SHOREHAM NUCLEAR POWER STATION

SNRC-1158

Submittal of FHAR Revision
Shoreham Nuclear Power Station - Unit 1
Docket No. 50-322

FIGURE 1
GENERAL ARRANGEMENT FOR THE
SHOREHAM NUCLEAR POWER STATION
SHOREHAM NUCLEAR POWER STATION-UNIT 1
FIRE HAZARD ANALYSIS REPORT

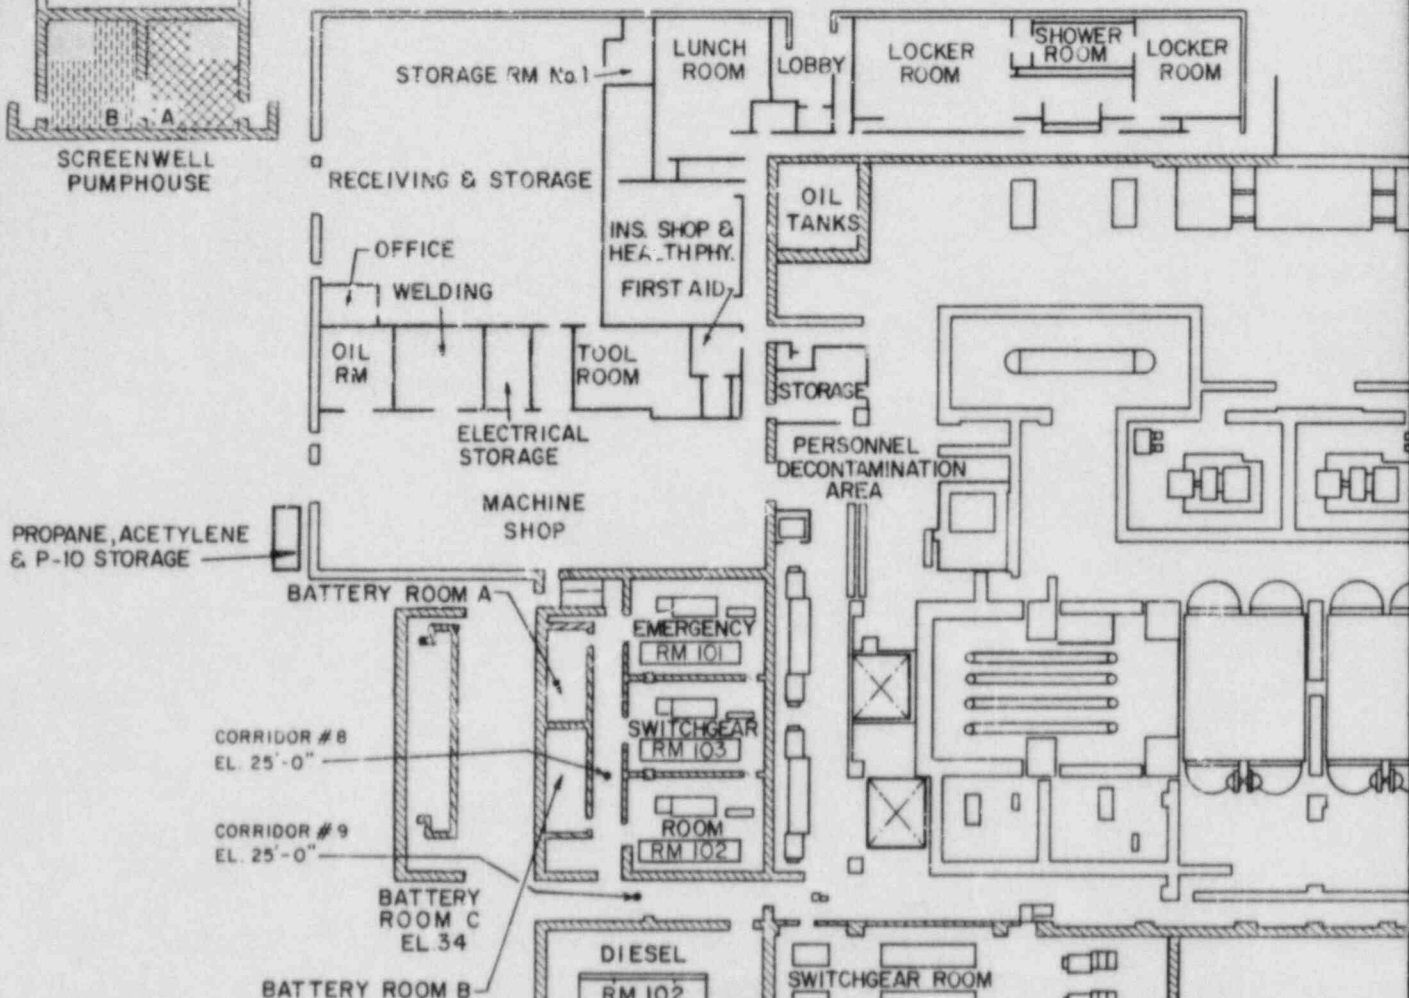
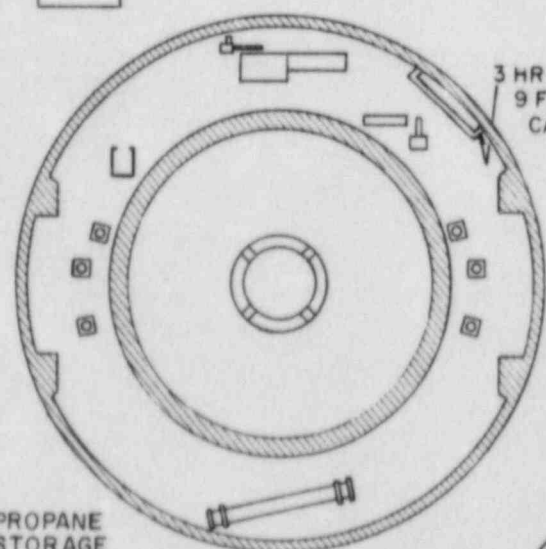
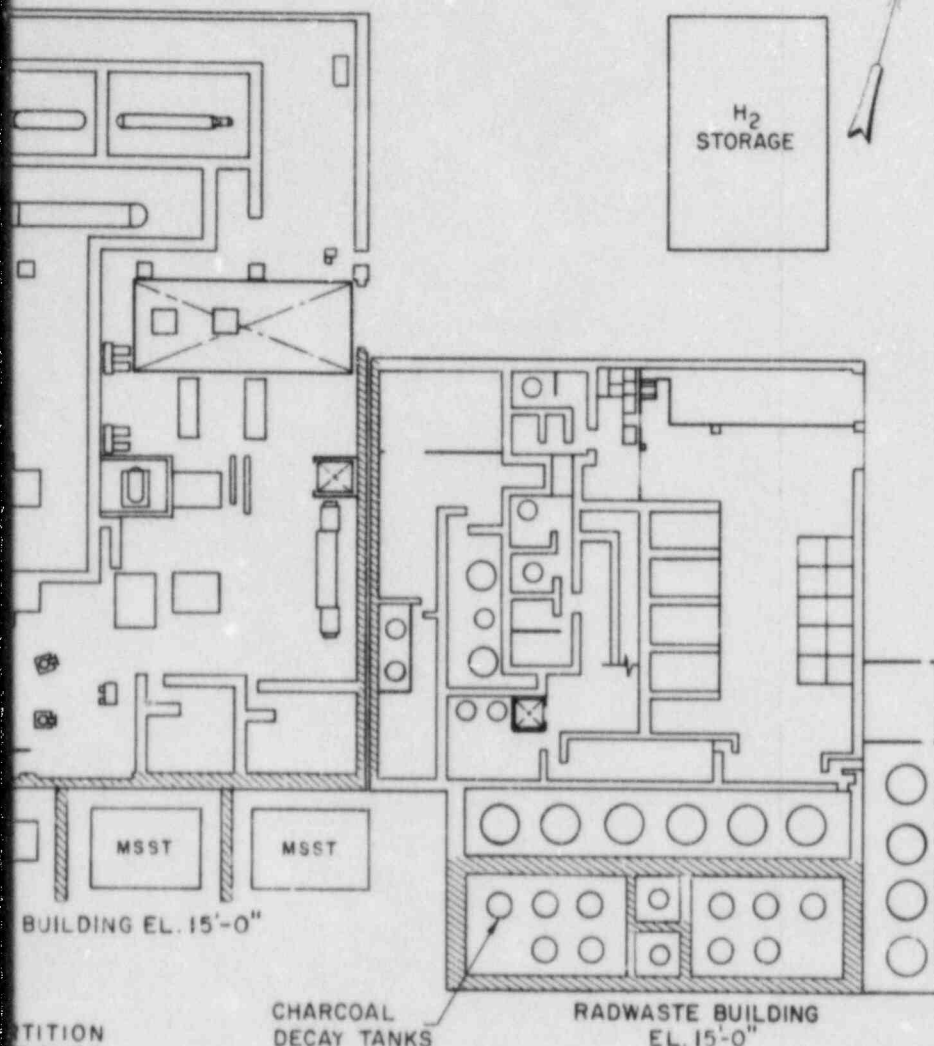
PLANT FIRE AREA DESCRIPTION - CORRIDOR NO. 8, El. 25 ft-0 in. -
CONTROL BUILDING (Refer to Figure 1)

PLANT FIRE AREA DESCRIPTION - CORRIDOR NO. 9, El. 25 ft-0 in. - CONTROL BUILDING (Refer to Figure 1)

FIGURE 1B
 ELECTRIC MANHOLE No. 1
 SHOREHAM NUCLEAR POWER STATION-UNIT 1
 FIRE HAZARD ANALYSIS REPORT

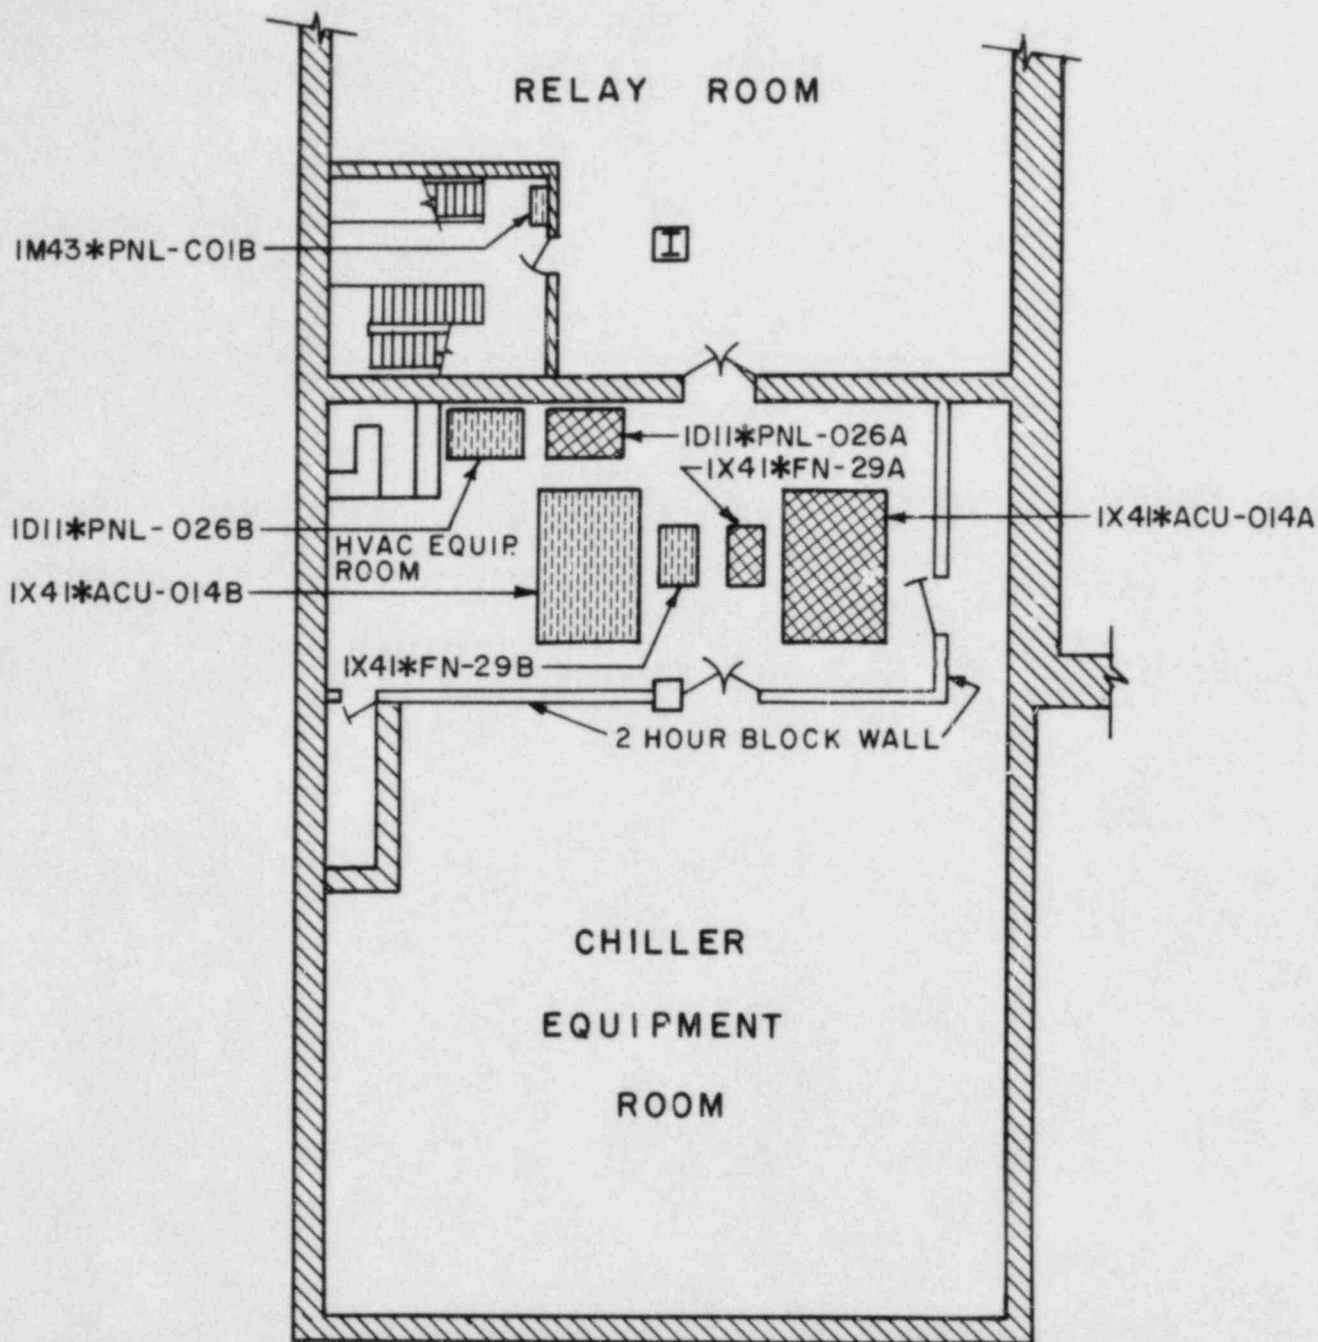
- 1) Item 84-46-10 - Design concentration of CO₂ in Battery Rooms and cable tunnel,
- 2) Item 84-46-13 - Lack of Fire Hazards Analysis for Electric Manhole #1 and Control Building corridors No. 8 and No. 9,
- 3) Item 84-46-09 - Lack of fire damper in duct between HVAC Equipment Room and Chiller Room.

PLANT FIRE AREA DESCRIPTION - ELECTRIC MANHOLE NO. 1
(Refer to Figure 1B)

Due to redundant (red) cable in duct 902 outside the area and the protective devices (breakers and/or fuses) at the orange cables in duct 900 (thus orange cables in duct 902 not affected), a

plant safe shutdown will not be impaired by the loss of blue and orange cables in the manhole (see Figure 1B).
